Construction Change Directive

PROJECT: <i>(Name and address)</i> Hidalgo County Remodel Old Admin Bldg 100 E Cano Edinburg, Texas 78539	DIRECTIVE NUMBER: 007	OWNER <input checked="" type="checkbox"/>
TO CONTRACTOR: <i>(Name and address)</i> D Wilson Construction P.O. Box 3455 McAllen, Texas 78502	DATE: October 8, 2014	ARCHITECT <input checked="" type="checkbox"/>
	CONTRACT FOR: General Construction	CONSULTANT <input checked="" type="checkbox"/>
	CONTRACT DATED: October 23, 2012	CONTRACTOR <input checked="" type="checkbox"/>
	ARCHITECT'S PROJECT NUMBER:	FIELD <input type="checkbox"/>
		OTHER <input type="checkbox"/>

PROVIDE LABOR AND MATERIALS FOR WORK DESCRIBED BY RFP 003.1 & RFP 022

REVISED HALL #197 - CEILING HEIGHT ADJUSTMENT

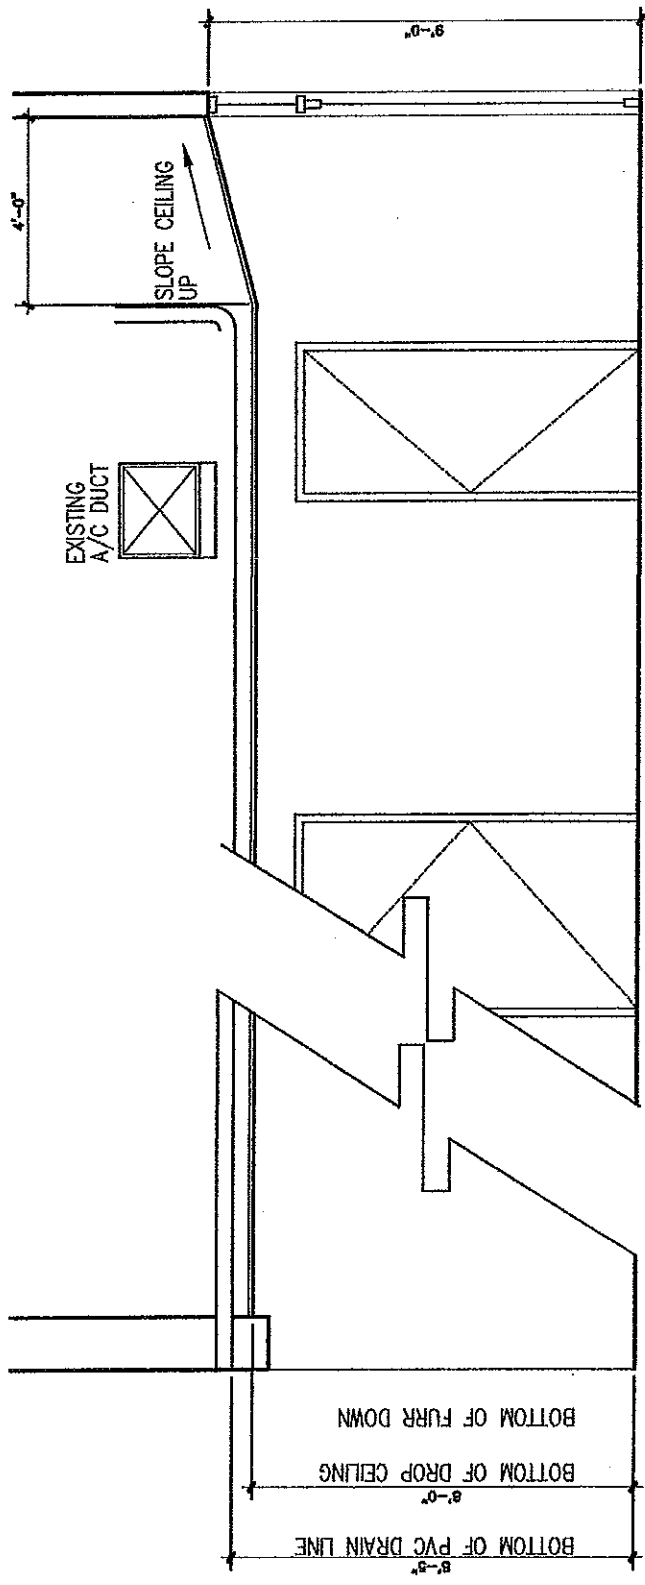
**REQUEST FOR PROPOSAL
003.1
NORTHWEST SECOND FLOOR
HALL 197 DRYWALL FURR DOWN**

Per today's Project Meeting, resubmit Change Request #64 to address the furr down at the north end of Hall 197 only.

Revised proposal for RFP #003. This proposal supercedes the previous proposal sent on 9.8.14. The furr downs in the Altrium are to remain at their original hieght. Work covers adjusting ceiling grid at entry door, framing, sheetrocking, T,F,T & Painting of a new fur down around an overhead SS line at Hall #197 as per RFP #003. Thank you.

**PROPOSEED
WALL EXTENSIONS
RFP 022**

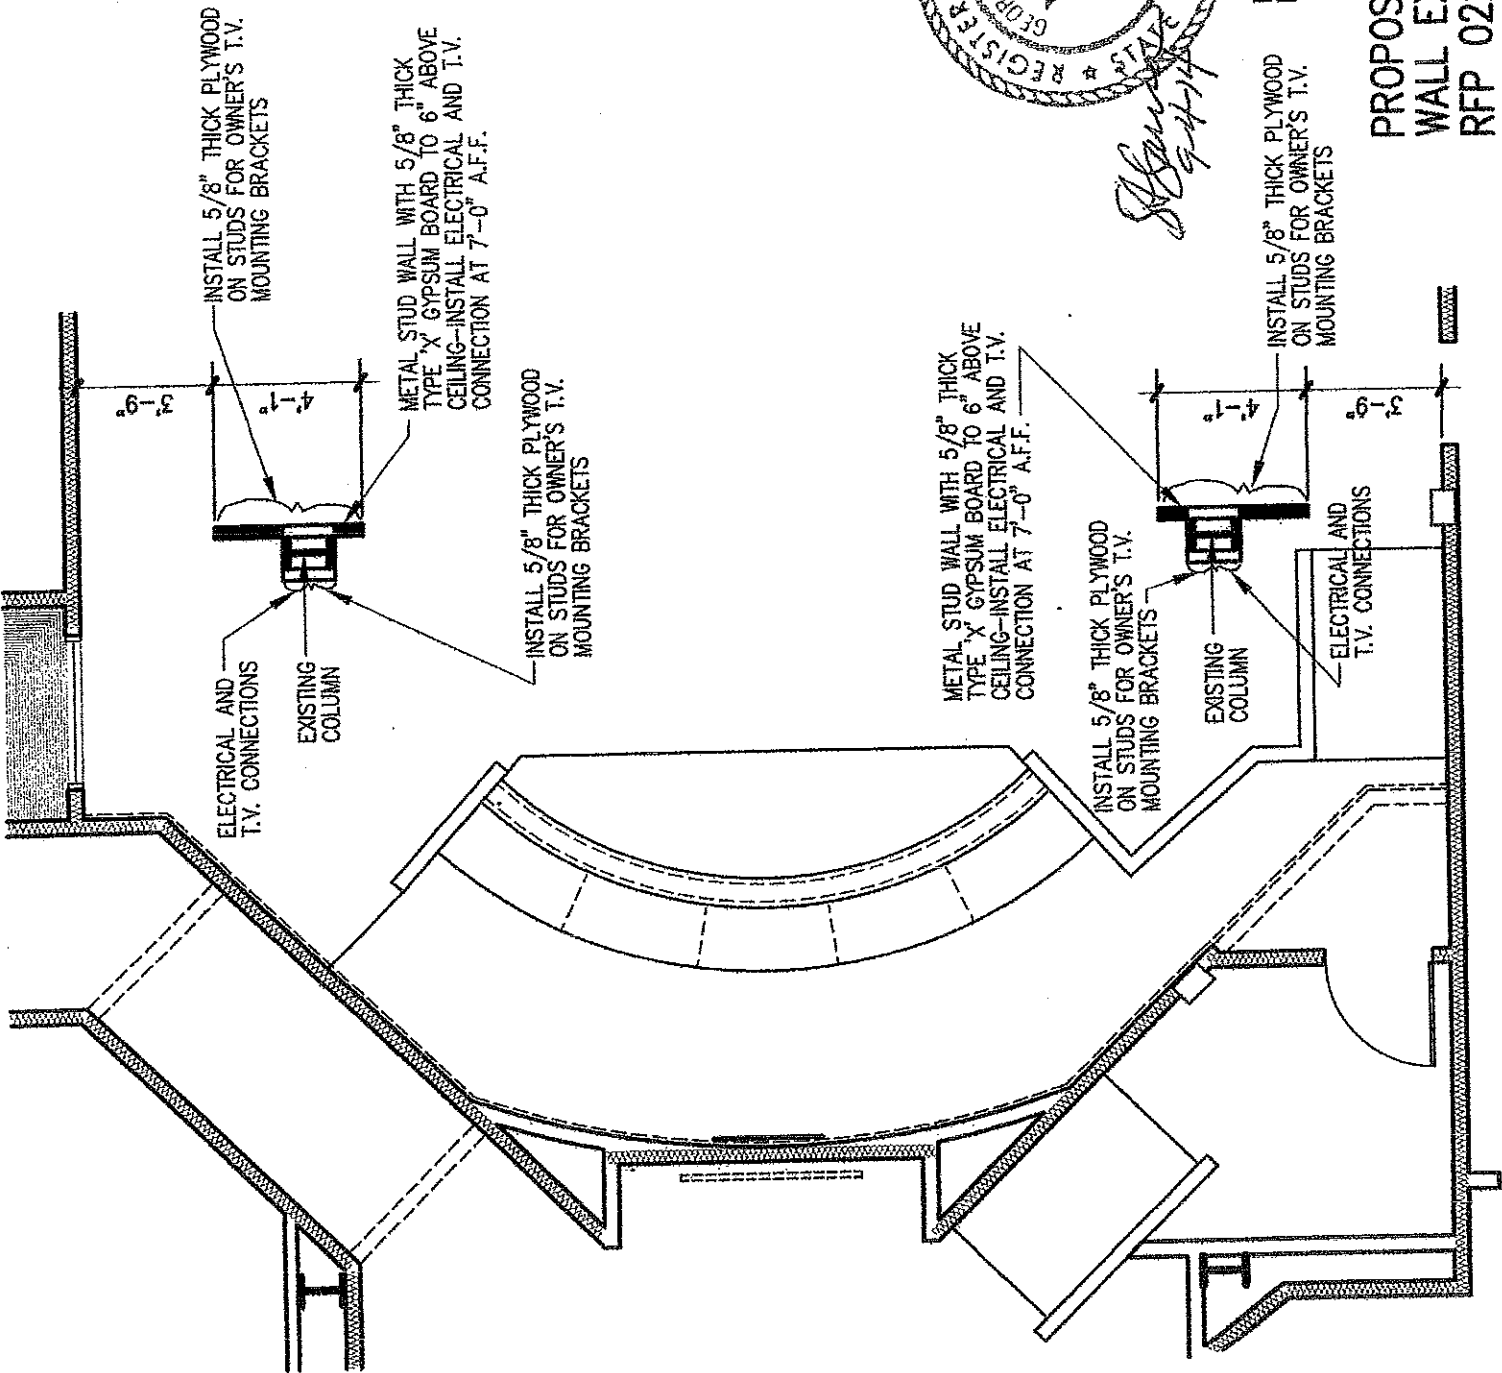
**REQUEST FOR PROPOSAL
022
REVISIONS TO
CCMR T.V. MOUNTING PARTITION
FOR PRICING PURPOSES:**

Provide cost, if any, for work as shown on attached drawings.

INSTALL 5/8" THICK PLYWOOD
ON STUDS FOR OWNER'S T.V.
MOUNTING BRACKETS

We are pleased to offer the following specifications and pricing to make the following changes:
Build two new wall sections in CC Meeting Room add electrical & TV outlets, T,F,T & Paint. . Work Per RFP #022.

REVISED REFLECTED CEILING PLAN
COUNTY JUDGE'S OFFICE 2ND FLOOR

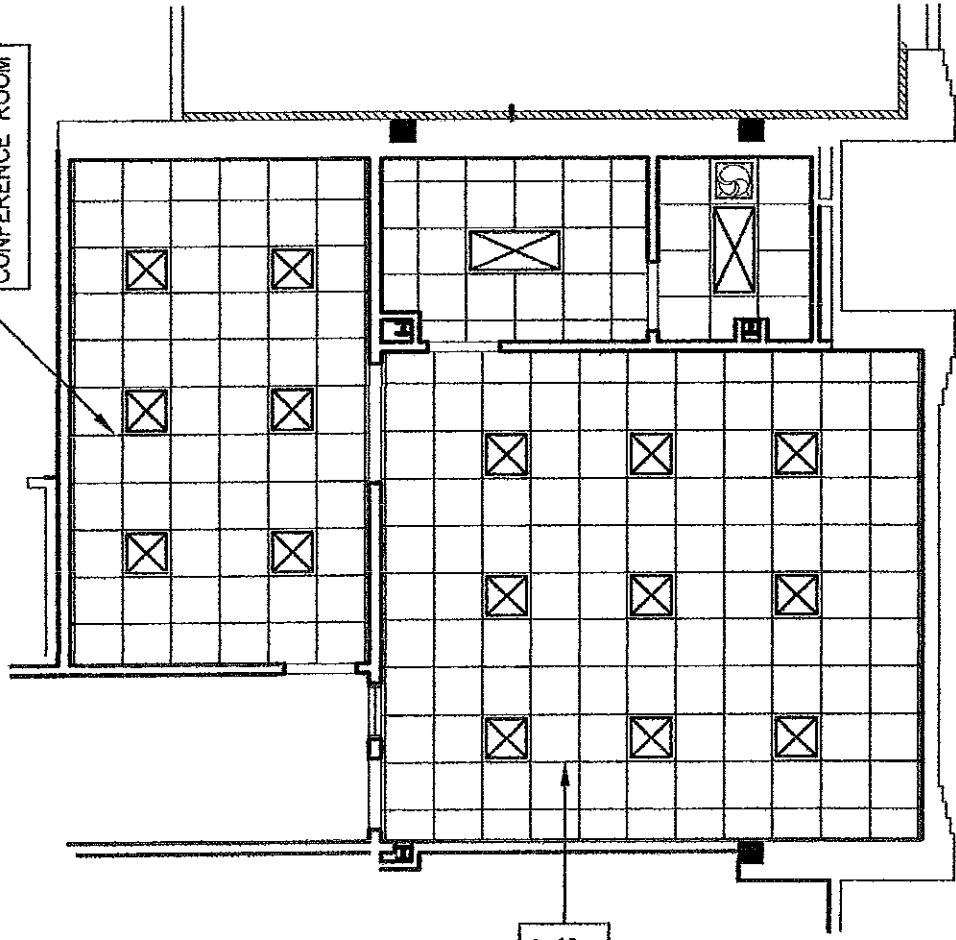
**REQUEST FOR PROPOSAL
016.1
REVISED REFLECTED CEILING PLAN
COUNTY JUDGES OFFICE
#C-6/101, 102, 103, & 104
LIGHT FIXTURE 'FD'**

Owner has rejected Metro Electric, Inc. September 11, 2014 Credit Proposal of Ninety Seven Dollars and no cents (\$97.00) for the omission of fourteen light fixtures type 'FD'

- Disregard Note # 2: Omit Recessed Down Light Fixtures.
- In lieu of Note #2, Install Light Fixtures 'FD' into revised ceiling plan (RFP 016).
- Locate Light Fixtures 'FD' as shown on Change-6 (C-6) Sheet Partial E-2/E-4.

1. SET CEILING HEIGHTS AT HIGHEST LEVEL POSSIBLE
2. OMIT RECESSED DOWN LIGHT FIXTURES
3. OMIT GYPSUM BOARD FURR-DOWNS SHOWN ON ORIGINAL PLANS
4. PROVIDE CREDIT TO OWNER FOR THE OMISSION OF GYPSUM BOARD FURR-DOWNS- L/M, T.F.T.&P. PLUS CREDIT FLOOR L/M FOR OMITTED LIGHT FIXTURES.
